CITY OF COCONUT CREEK

DEVELOPMENT REVIEW COMMITTEE (DRC) REVIEW #3 – APRIL 24, 2024

| PROJECT NAME: | MainStreet Block 11 | | |
| REVIEW/APPLICATION: | PMDD Site Plan | | |

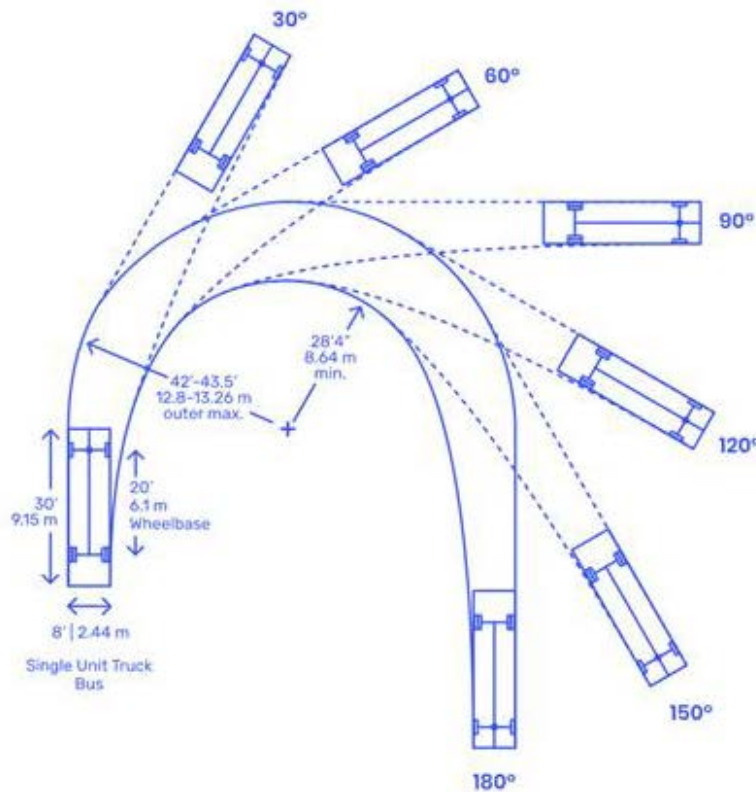
1. Fire department access roads shall be provided such that any portion of the facility or any portion of an exterior wall of the first story of the building is located not more than 150 ft. from the fire department access roads as measured by an approved route around the exterior of the building or facility (NFPA 1-18.2.3.2.2). Shall be permitted to increase to 450 feet if the building is equipped with an approved automatic sprinkler system.

The Fire Truck Route Plan shall show turning radius dimensions.

A vehicle's turning circle is the radius (or diameter) measured by the outer wheels of the vehicle while making a complete turn, without any physical conflicts (i.e. curbs, light poles, fire hydrants, etc.);
